MEMORANDUM

SUBJECT: Groundwater Comments to the Site Inspection of Aqueous Film Forming Foam (AFFF) Release Areas Environmental Programs Worldwide Installation-Specific Work Plan Fairchild Air Force Base Spokane, Washington

DATE: January 12, 2017

Figure 2: Location of well MW-399 by the known PFC release next to Fire Station 1.

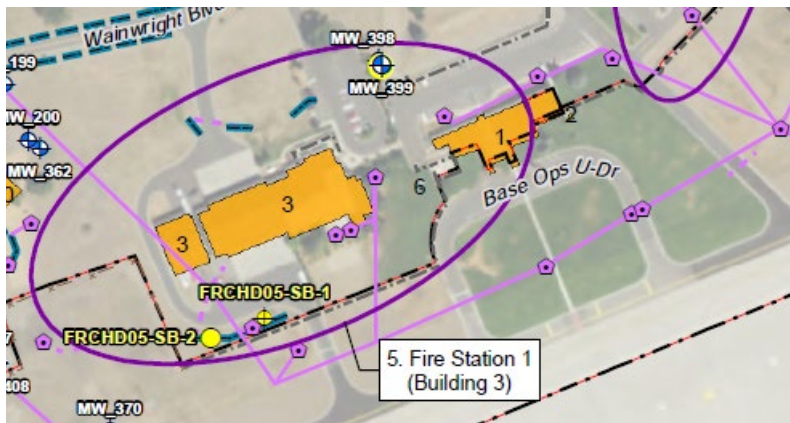
For Fire Station 1 (Building 3) there does not appear to be an existing well ideally located downgradient of the known release. As seen on the figure below (from Figure 5 in the document), well MW-399 is located slightly north of the groundwater flow direction which is more easterly from the release point. Thus this groundwater well may not pick up a detect. However, I do not see a good alternative. But a negative detect in well MW-399 does not mean that PFCs are not present in the groundwater from this release.

Figure 3: Well locations where groundwater samples could be collected near retention pond.

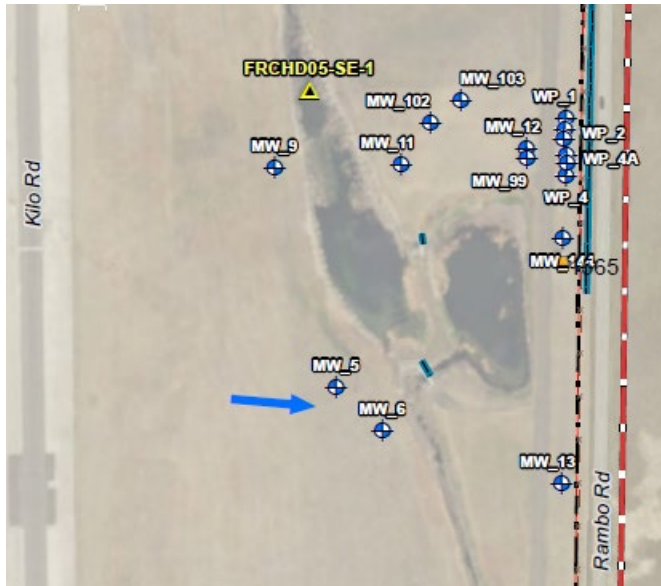
Related to this release, the plan is to also collect a single sediment sample (FRCHD05-SE-1 on Figure 3 in the document) from the retention pond on the east side of the base since part of the contaminated water from the calibration testing may have entered a storm drain that discharges to this pond. The document states that the water in this pond either infiltrates to the groundwater, or evaporates. As such, it would be important to collect a groundwater sample

close to this pond. Example wells that may be good candidates include MW-13 and MW-144 (Figure 3 below which is part of Figure 3 in the document). Related to this sampling point, the table in the section QAPP WORKSHEET #18-5: SAMPLING LOCATIONS AND METHODS AFFF RELEASE AREA 5: FIRE STATION 1 (BUILDING 3) identifies this sampling point as FRCHD05-SD-1.

Figure 4: Wells and soil to be sampled by Crash Site SS008.

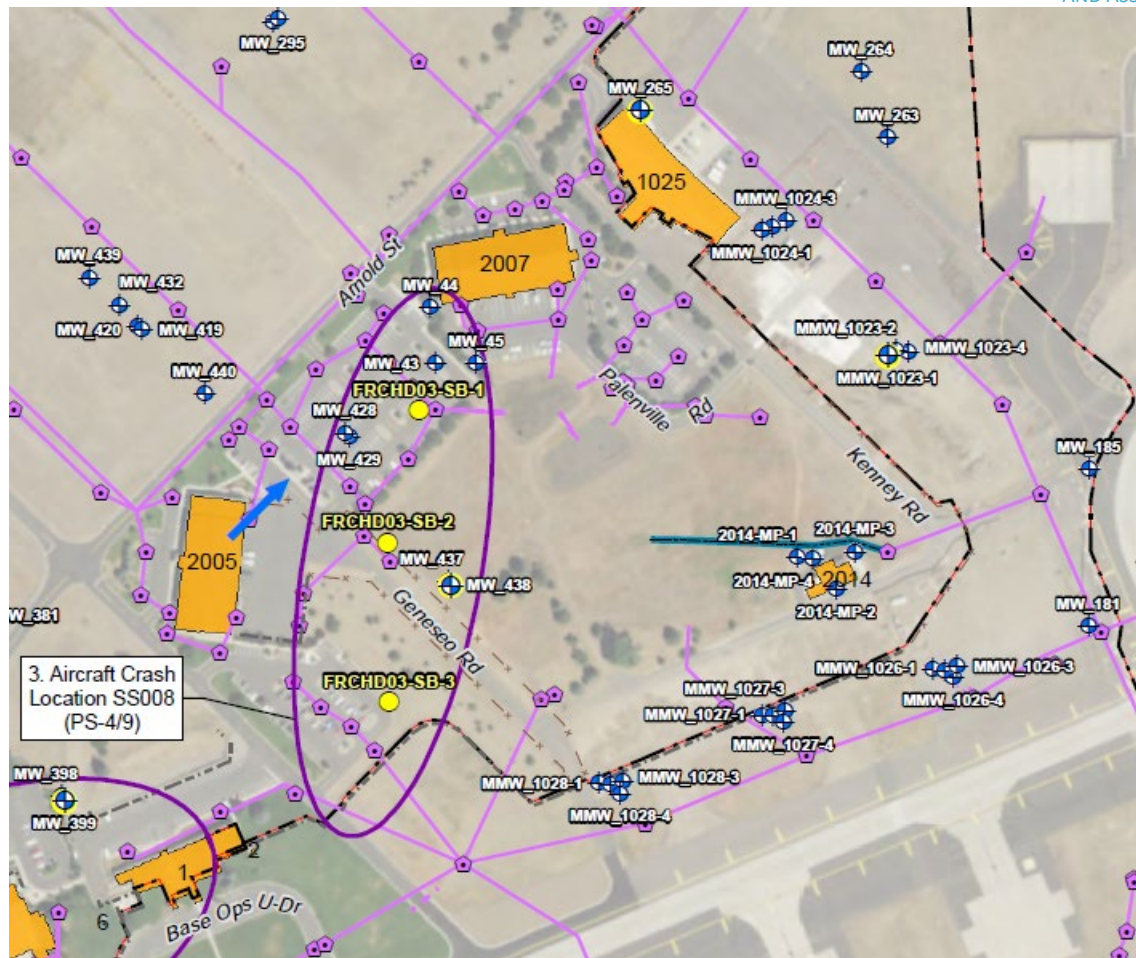
For the Aircraft Crash Location SS008 (PS-4/9), three borings will sample the soils along the axis of the crash site, and groundwater samples will be collected from three wells downgradient of the site. These wells include MW-438, MW-265, and MMW-1023-1 (Figure 4 below from Figure 5 in the document). If the TCE plumes that have previously been mapped for this site are an indication of groundwater flow, then it should be noted that well MMW-1023-1 is not in either the shallow alluvium TCE plume, nor the weather basalt TCE plumes (Figures 5A and 5B below). Thus an additional sample from well MW-185 could help to determine the presence of the PFCs if they are flowing within the weathered basalt.

Figure 6A: B52 crash site and groundwater flow direction.

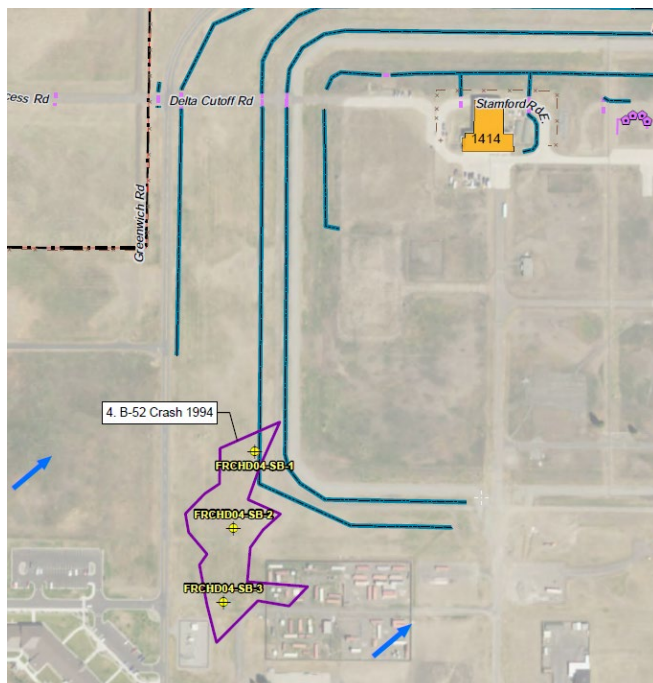
B-52 Crash Location 1994 will have three soil borings, and three groundwater sample from each of these borings. As can be seen on Figures 6A and 6B below, wells MW-451 and MW-452 are directly downgradient of this crash site and would be good candidates for collecting a groundwater sample.
